NOVEMBER 2017 GEOTECHNICAL INSPECTION REPORT

BHM Project No. 17-118

BAFFINLAND IRON MINES CORPORATION

MARY RIVER PROJECT

18. Waste Rock Stockpile Pond (MS-08) (Snow) See Drawing.

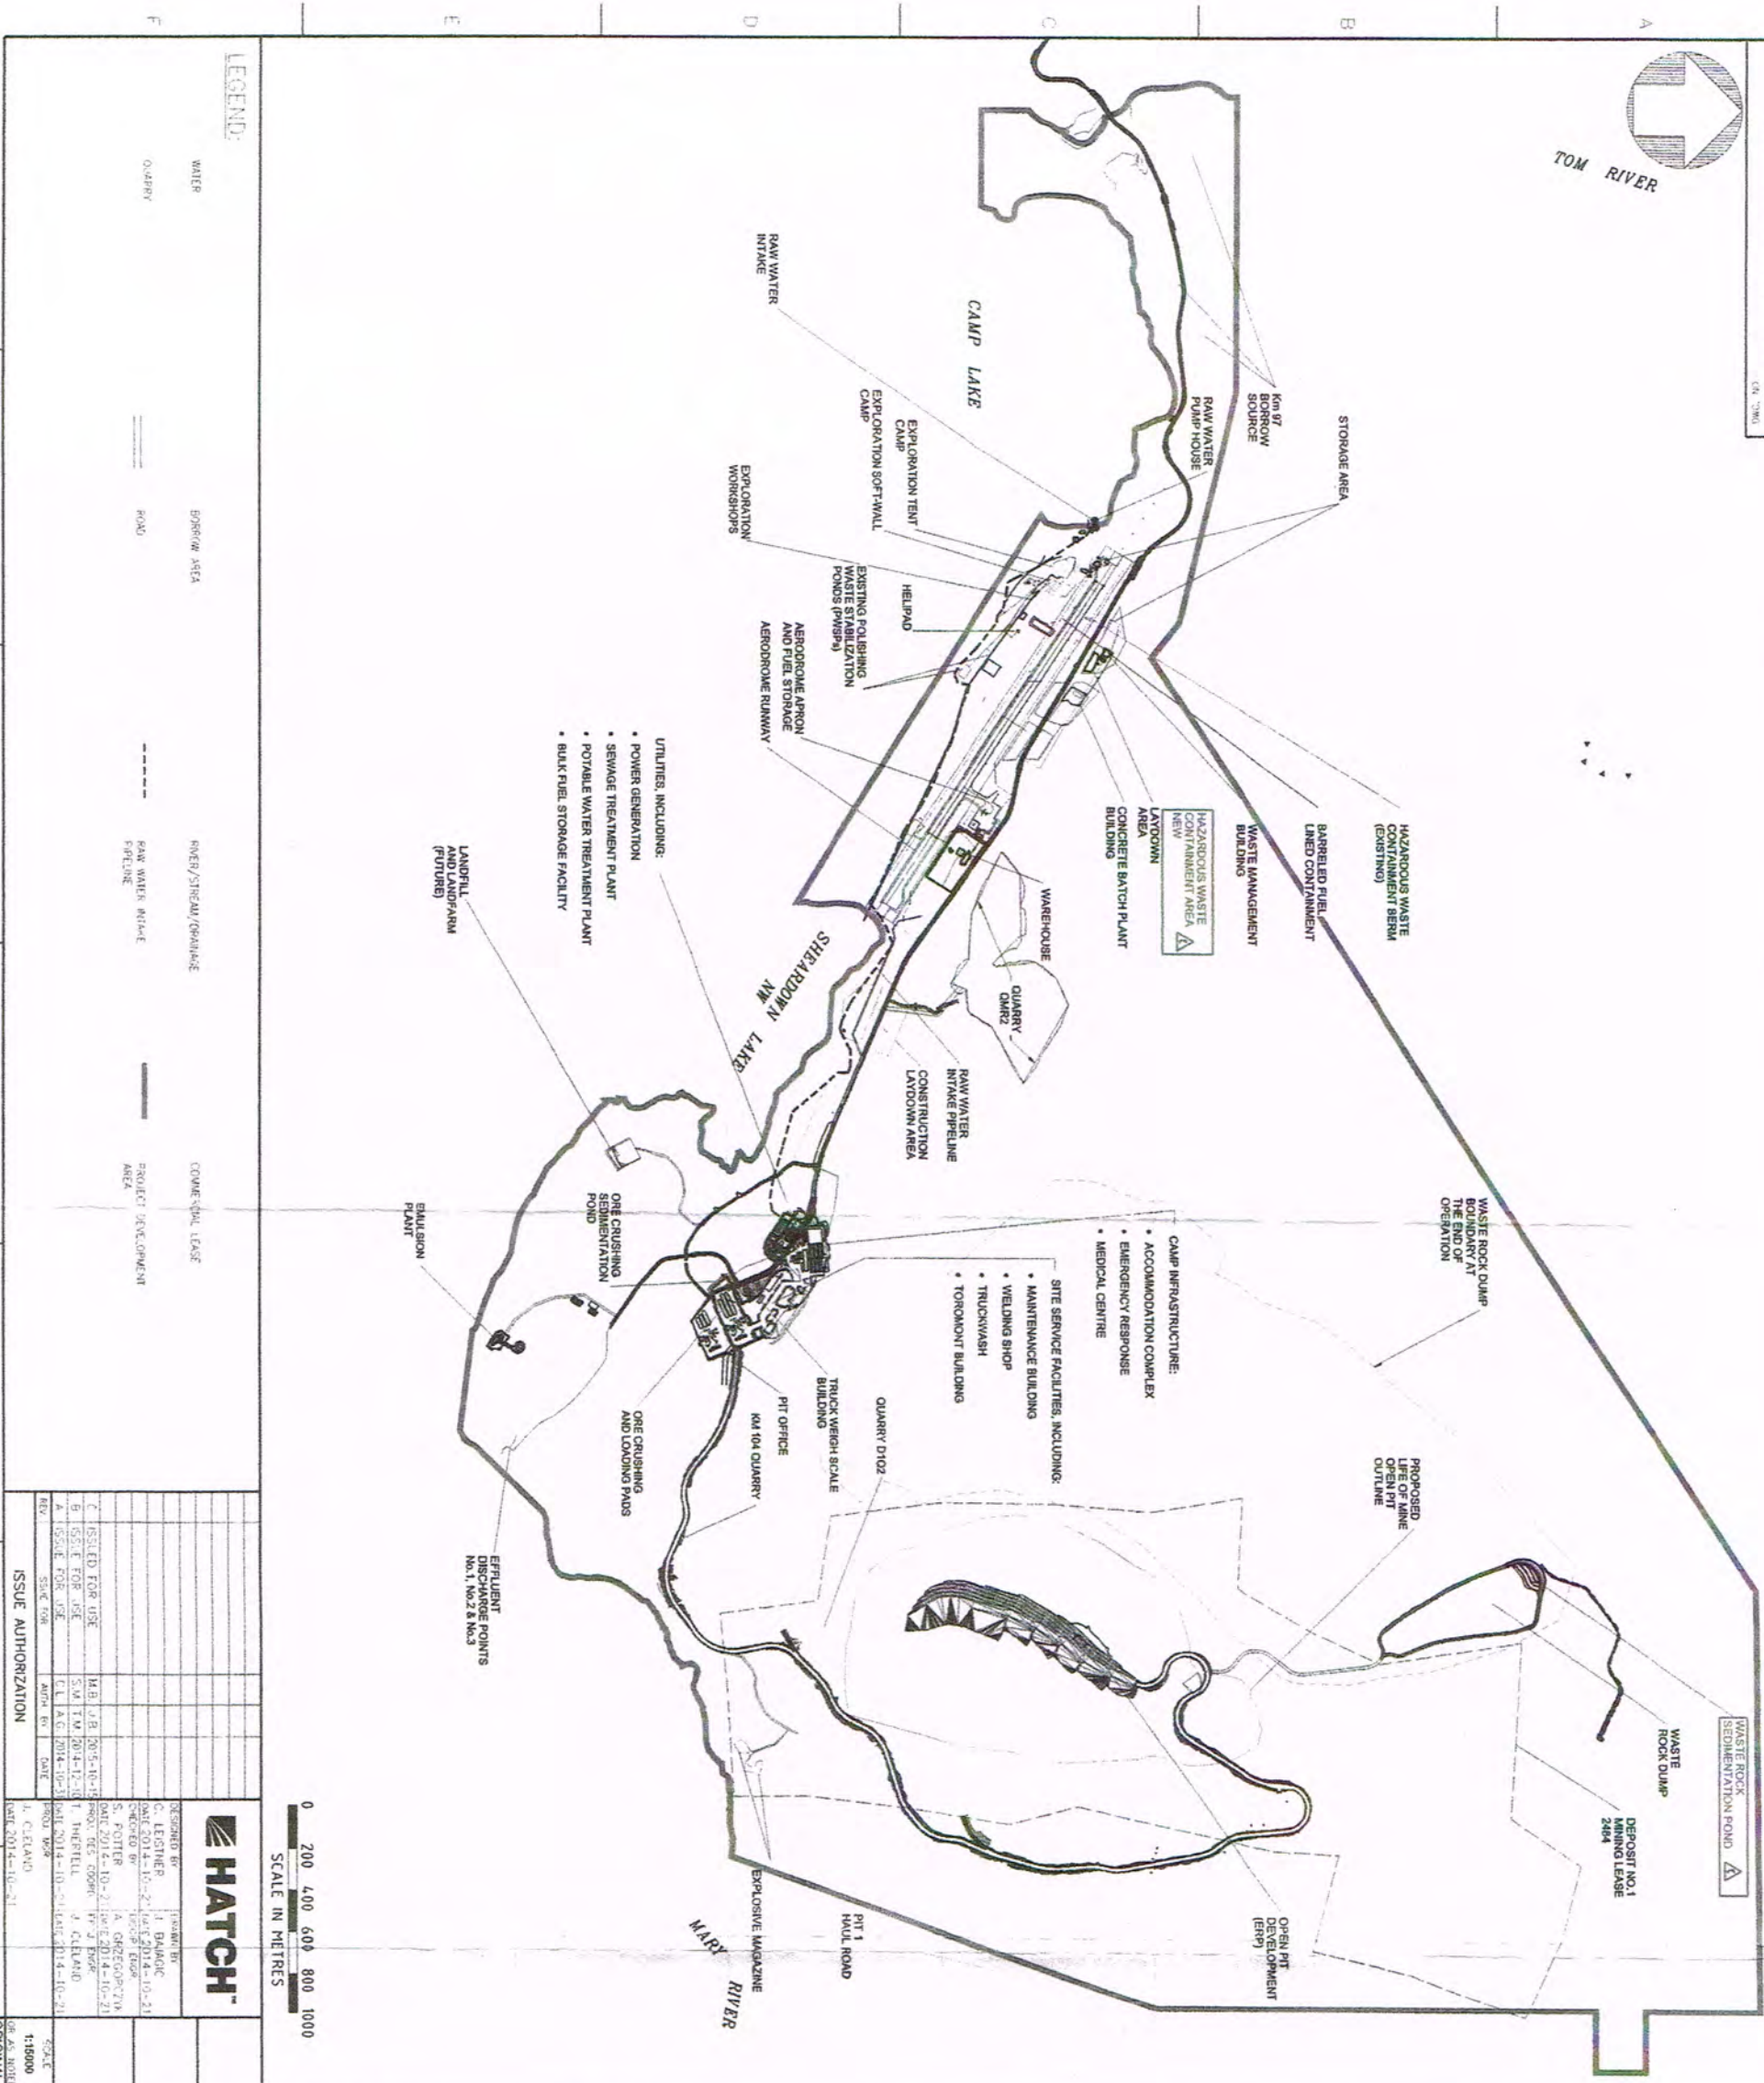
As we were inspecting the drainage containment, we were advised that tests on the water in the catchment area had shown the water to have a low pH.

At the time of our inspection at the top of the hill a sudden snow storm covered the area so we could not readily review the additional catchment “sumps” and ditches placed to catch water not contained by the original ditches and containment. Baffinland continues to investigate the seepage observed originating from the toe of the Waste Rock Sedimentation Pond in 2017.

Revisions to this facility are expected to be made following a review by the Mine Operations at the site.

When weather permits, the integrity of the existing pond should be restored.
